ADDENDUM

Project Name:	Kosciuszko Middle School Toilet Room Upgrades	Addendum No:	One (1)
Project Number:	16-118	Issue Date:	April 29, 2016
Project Location:	Hamtramck, Michigan

To the Contract Documents for the requested Kosciuszko Middle School Toilet Room Upgrades

P100

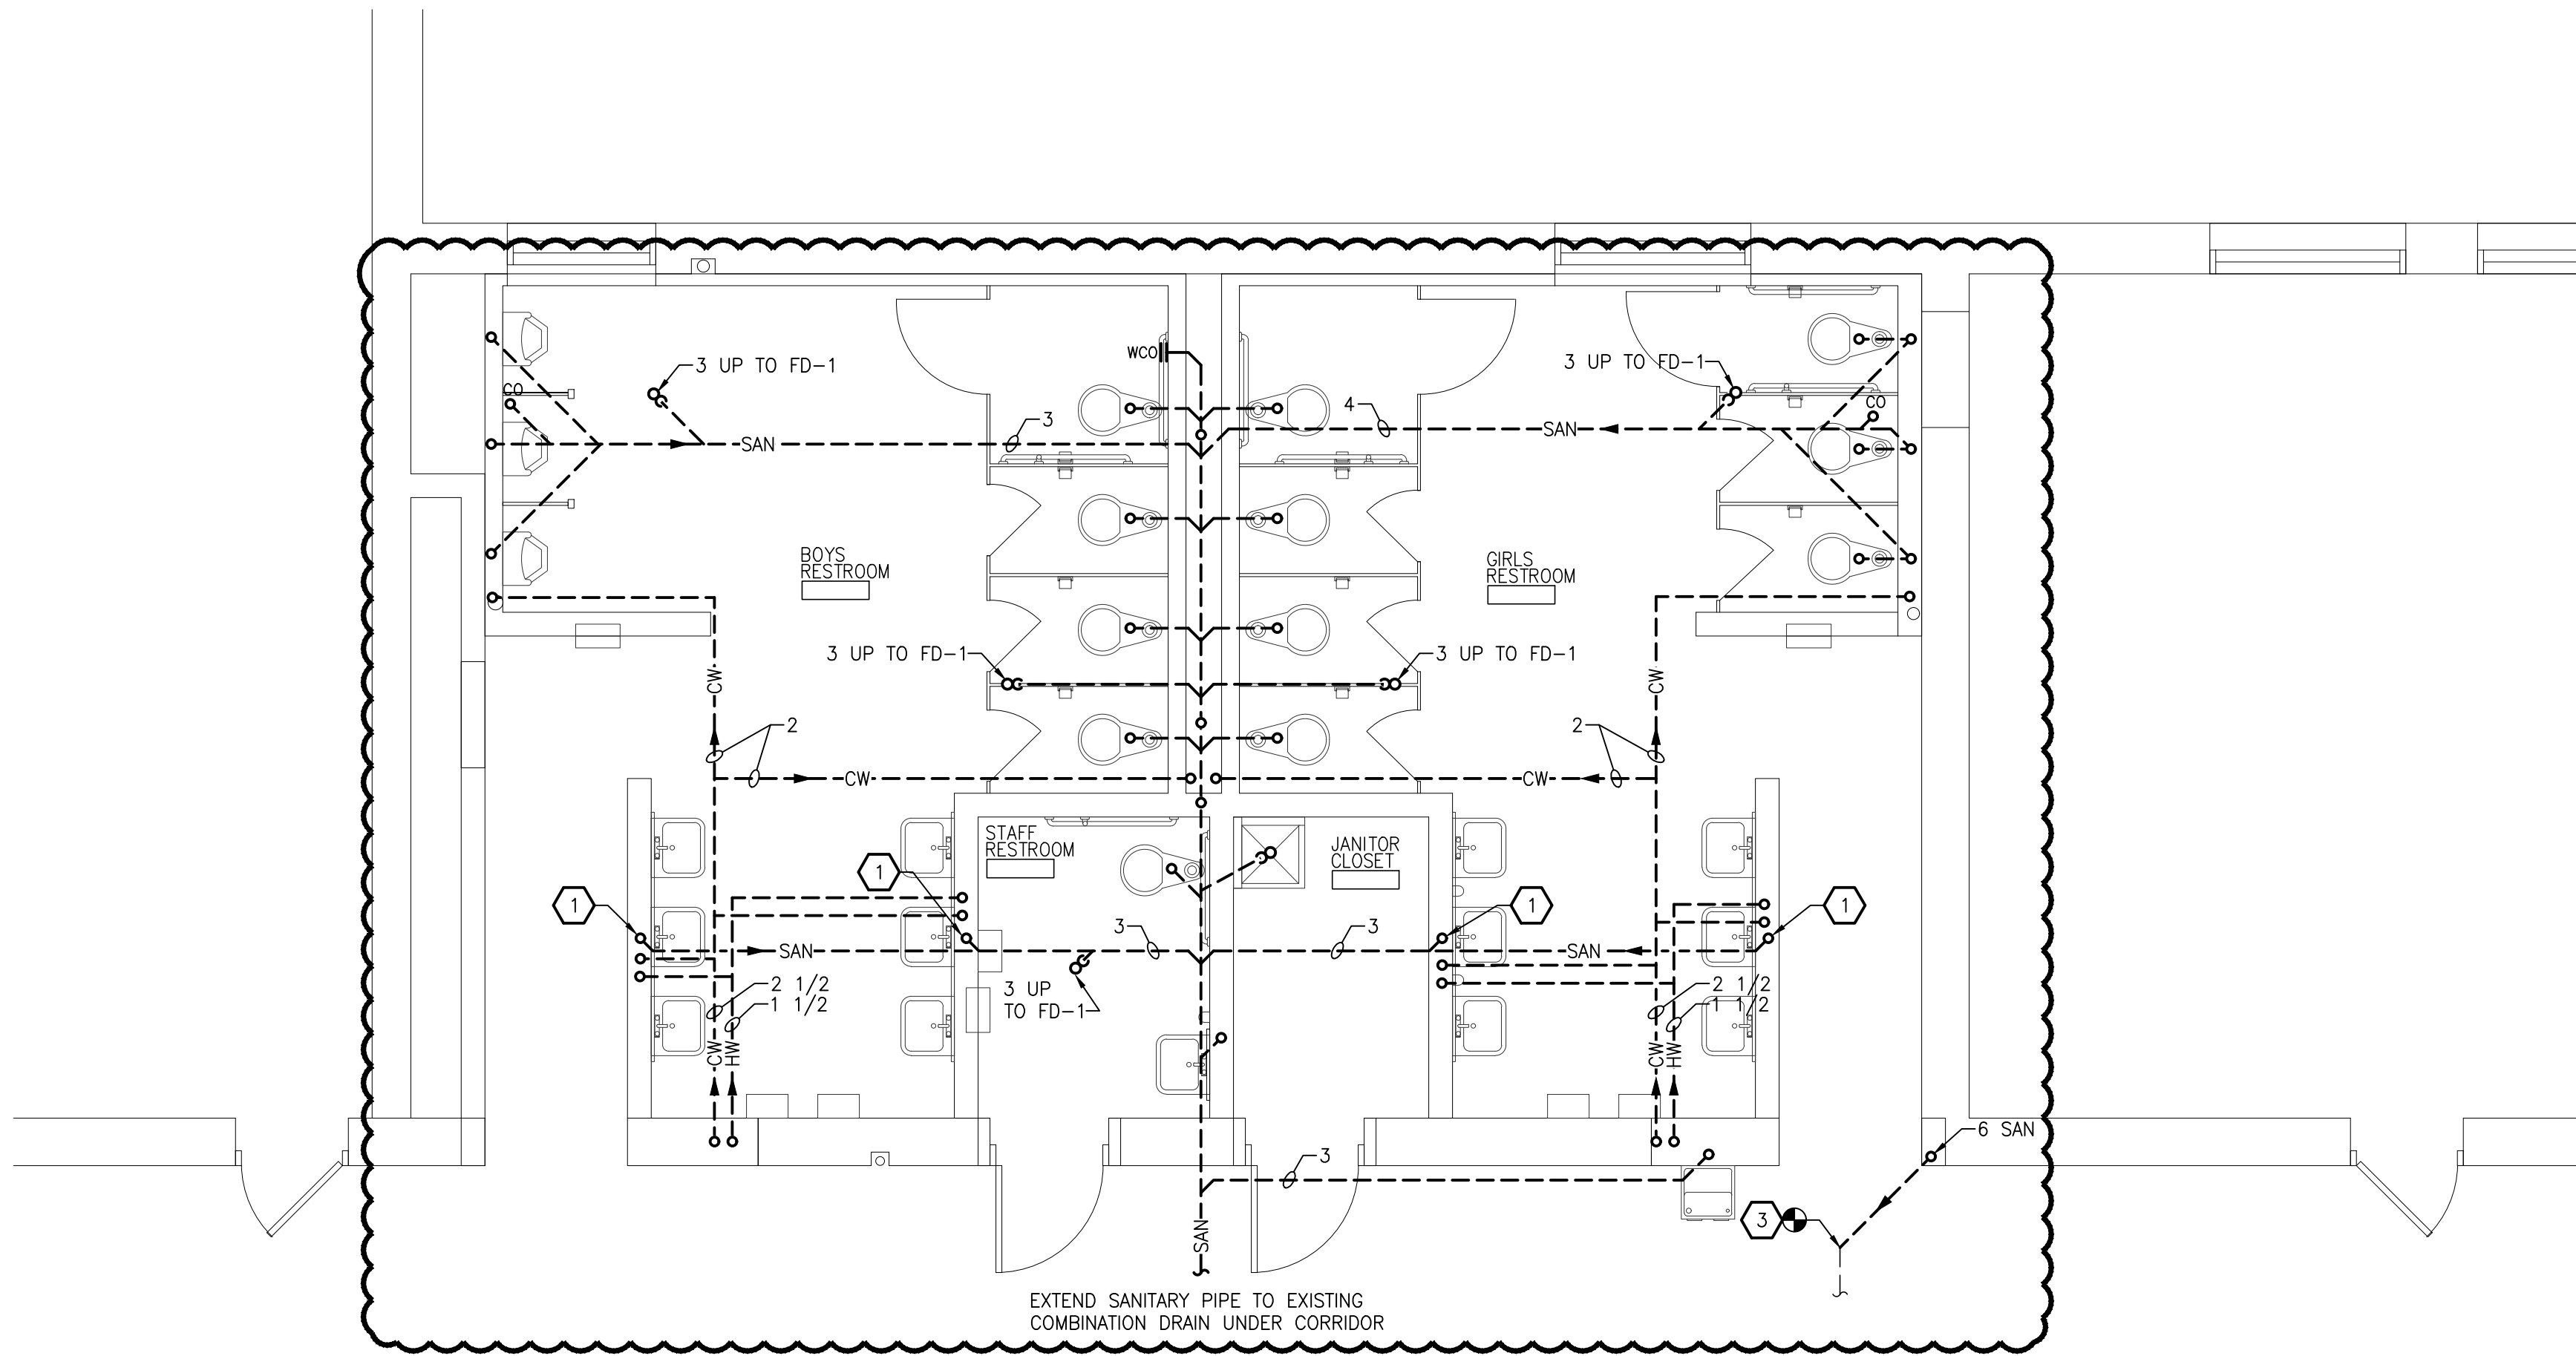
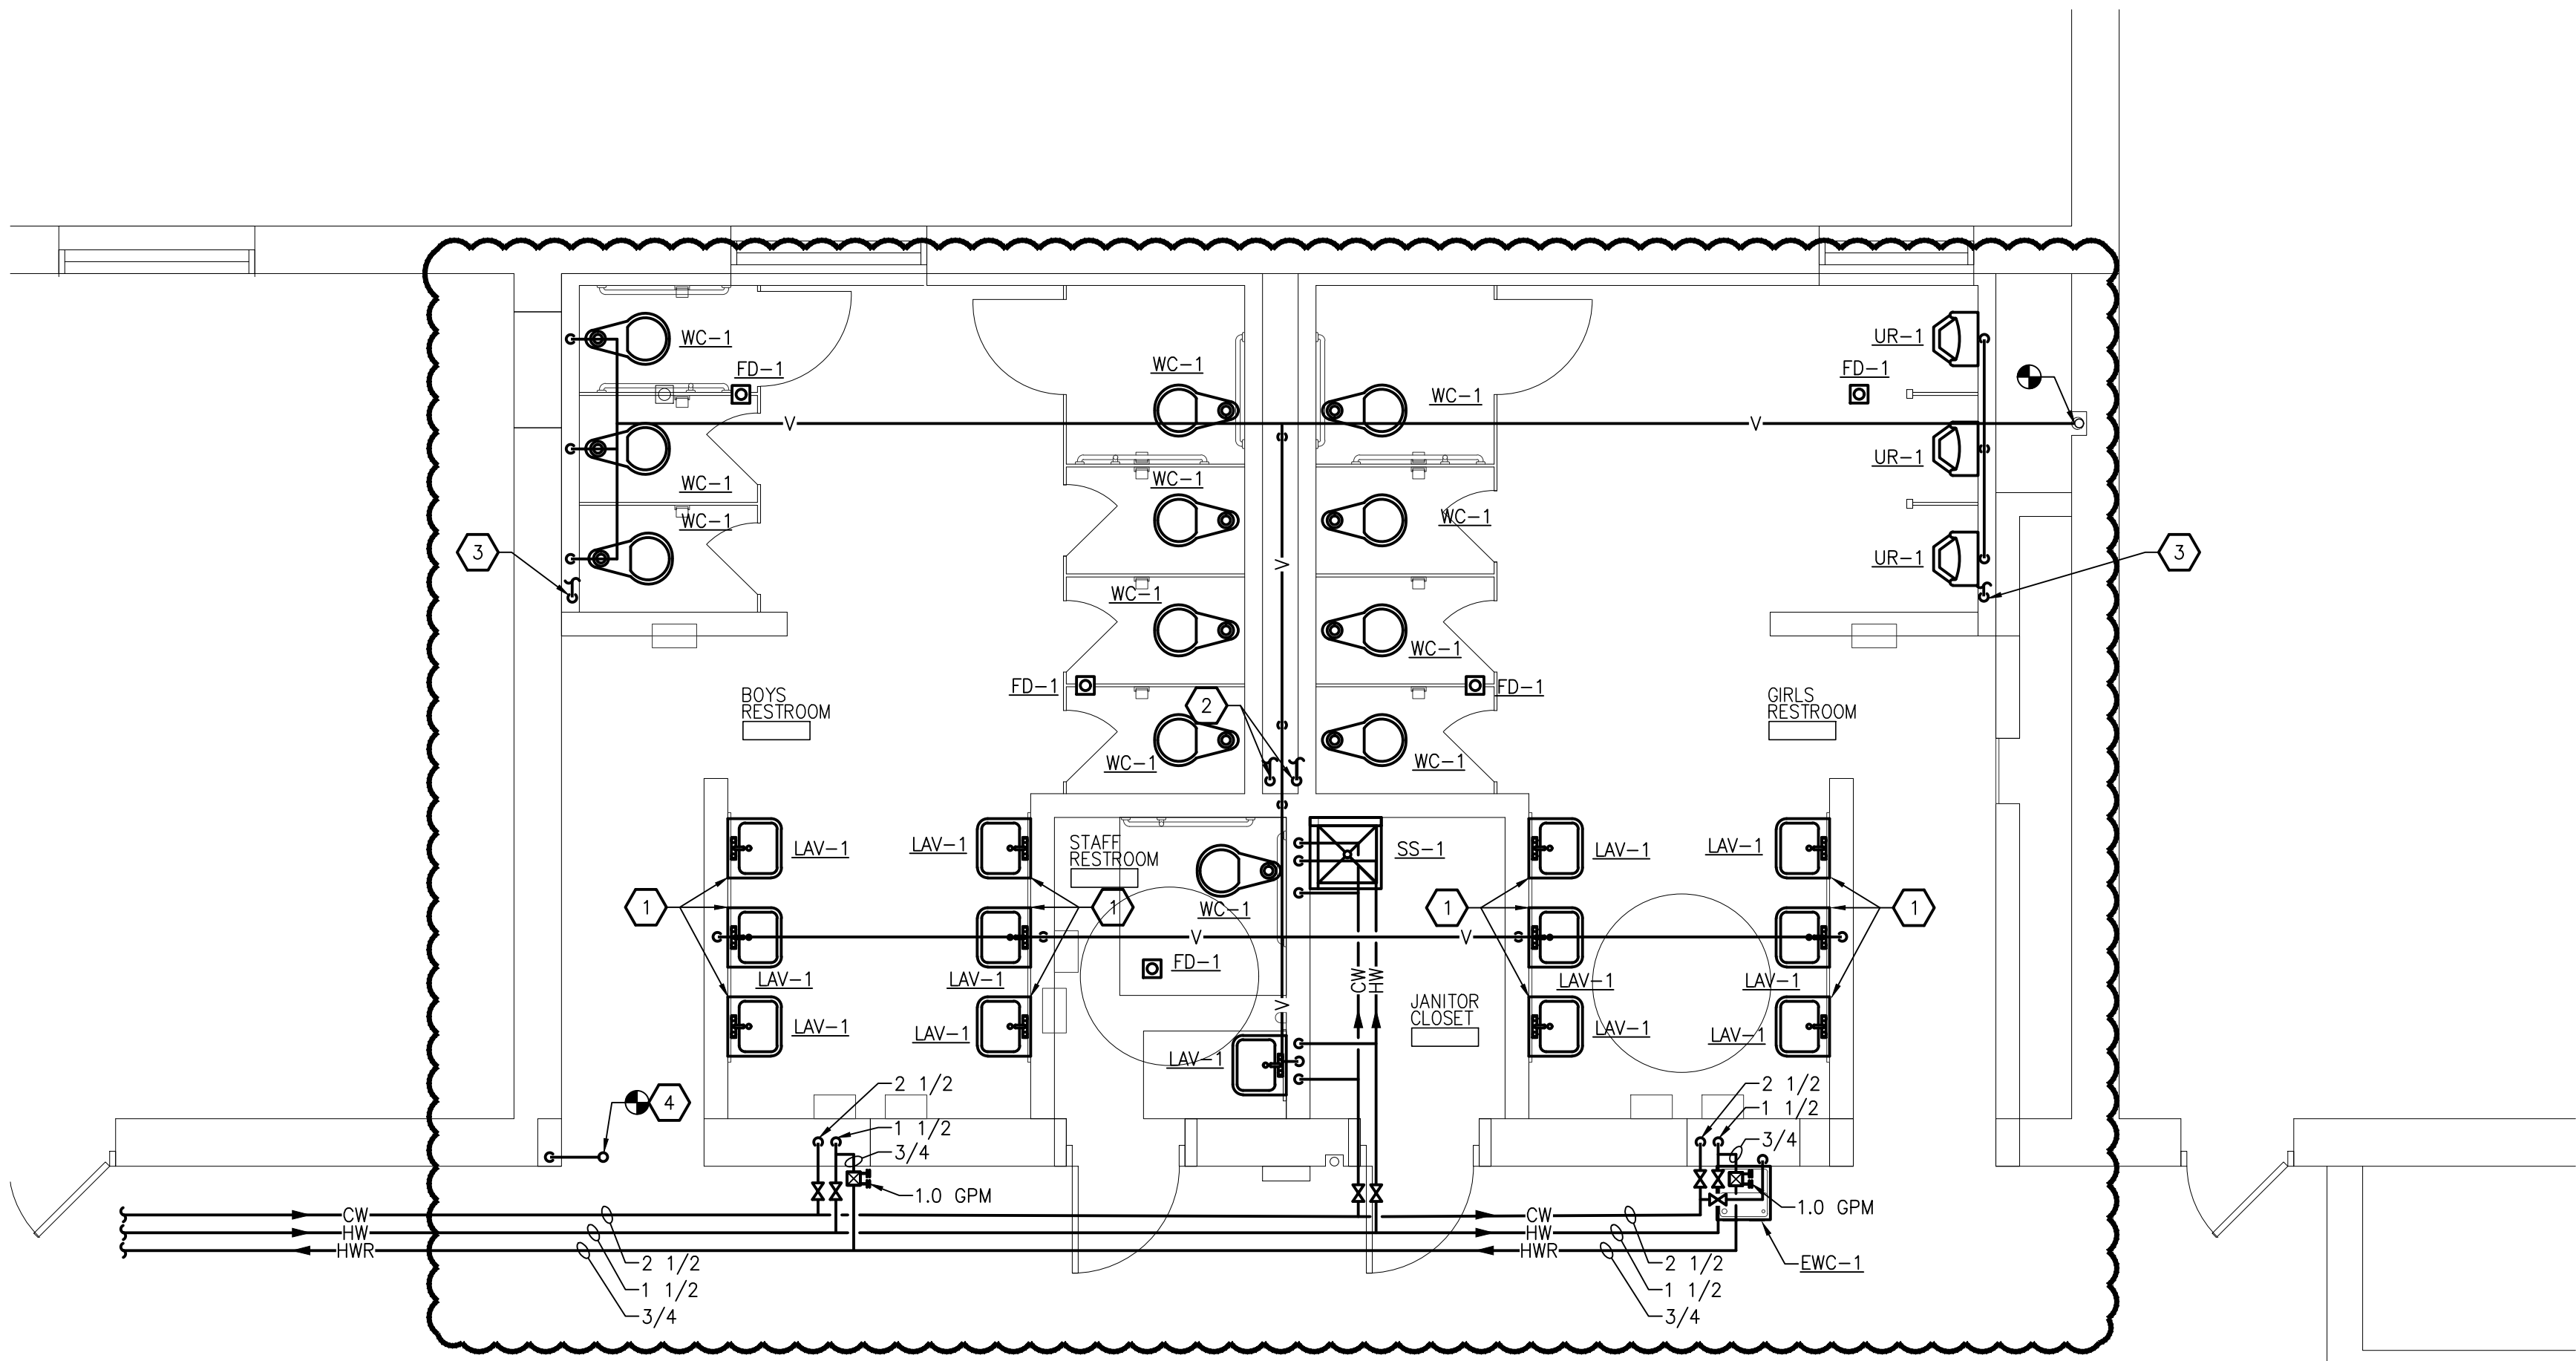
Item M1 Drawing P-100; Partial Underground Plumbing Plan (revised and reissued this Addendum)
A. Add electric water cooler (EWC-1) sanitary piping Area A
B. Clarify EWC-1 sanitary piping in Area B

- C. Revised domestic hot water and cold water piping serving boys and girls restrooms in Area A and Area B to route underground.
- D. Revised key note 1 to include hot and cold water piping
